1 re: ballot comment #15, maintenance request 0286

2 802.1Q-Rev Project Editor, Mick Seaman

3 This document is a project editor's discussion of, and proposed resolution to, ballot comment #15, which itself
4 was a request to implement maintenance request 0286. This comment and the others received on this ballot
5 can be found in the proposed disposition of comments (later revisions of the proposed disposition may be
6 found in the same directory):

20 The proposed replacement Fig 8-20 (above) differs slightly from the recorded resolution of maintenance
21 request.

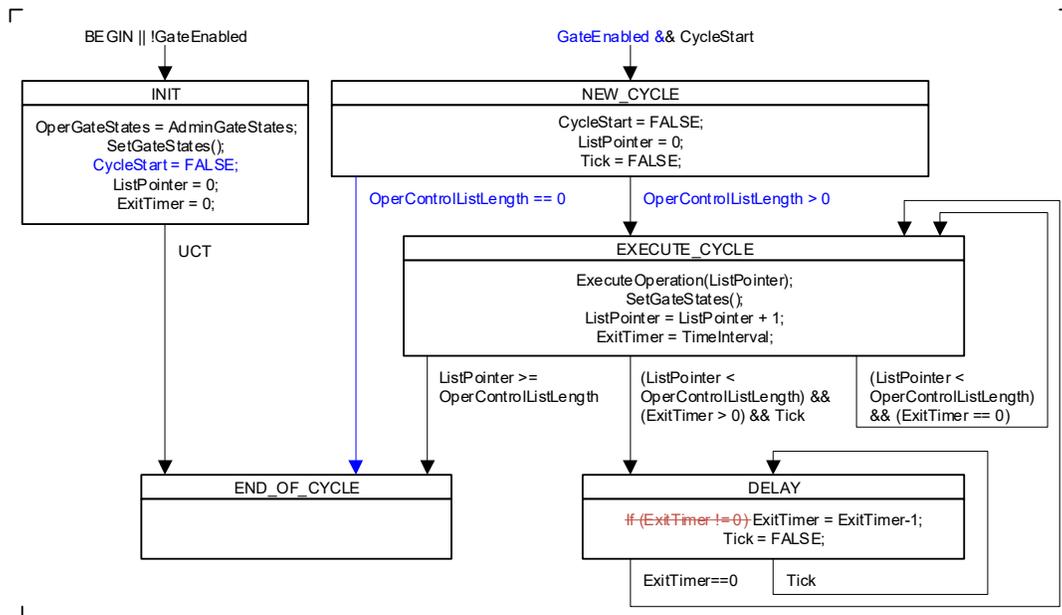
10 I propose that we adopt the replacement Figure 8-20 shown in this document (with **insert** and **strikeout** for
11 suggested technical changes) for the next WG recirculation ballot. Notes on the changes from the
12 P802.1Q-Rev/D0.4 version follow the figure, and include notes on the changes from the first proposed
13 change. Minor editorial change suggestions for readability are not shown. These include consistency of test
14 conditions in transitions and consistency of variable setting order in states. Since the actions in each state are
15 specified as occurring atomically and the state machine definition further requires that the entry condition to
16 the state be true when that atomic execution takes place,, these readability changes have no technical effect.

22 1. The state machine conventions (see Annex E of 802.1Q) do not specify behavior when both UCT and
23 another condition are True for exit from a state. Other descriptions of this state machine logic have
24 maintained that the choice of next state is undefined when multiple conditions apply. Annex E does specify
25 the use of ELSE, which would resolve the issue in the present case. However explicitly representing the
26 two cases of a zero and non-zero list would seem to be clearer in this case.

- 1 2. Given that clarification it would be possible to simply not leave the NEW_CYCLE state at all if the list length
2 is zero, but this would risk leaving the state at an unaligned time when the list length was changed, and the
3 END_OF_CYCLE state (which has no action, and could have been omitted) was presumably included for
4 clarity of documentation.

- 5 3. The state machine behavior in the case of !GateEnabled and CycleStart both being True is undefined
6 [BEGIN is special by convention (and it and open transitions in general should be better described in
7 Annex E, but that should be left for another day) and does not suffer from this problem. In general state
8 machines should follow the rule that correctness is a local property, and in this case of this machine the
9 issue is not resolved within the set of related state machines as none of the machines appears to control
10 the relationship between GateEnabled and CycleStart. I believe it is the case that NEW_CYCLE should
11 not be entered if GateEnabled is False. The open entry to NEW_CYCLE is then best qualified
12 GateEnabled && CycleStart. To guard against a randomly time start occurring due to a transition to
13 GateEnabled True revealing a previous CycleStart it would also seem wise to reset CycleStart in INIT.

14 Notionally the open transition to INIT continuously executes the INIT actions so that the variables set/reset
15 in that states actions will have the assigned values up to the point that BEGIN becomes False and
16 GateEnabled becomes True.

- 17 4. The test (ExitTimer != 0) was unnecessary in state DELAY. The state will not be entered if ExitTimer is not
18 greater than zero. If there is any worry about failure to evaluate ExitTimer == 0 to exit the state after the
19 state actions set Tick = FALSE then the Tick exit could be qualified with (ExitTimer != 0) , but that would be
20 an unusual interpretation of the machines.

- 21 5. **The issue:** the current understanding of the editor this is that the desired timing of each successive
22 ExecuteOperation(.) is meant to be (for some at least) in synchronized time, while the Tick specified is an
23 approximation (and unless the Tick occurs at the finest granularity of synchronized time possible the whole
24 notion of counting down using a Tick that is not itself synchronized with synchronized time would by its
25 nature yield an approximate time, even if the duration of the Tick was precise). The Editor does not see
26 how this issue can be fixed by simple changes to the figure and it probably has much wider consequences,
27 outside of the scope of the current ballot resolution
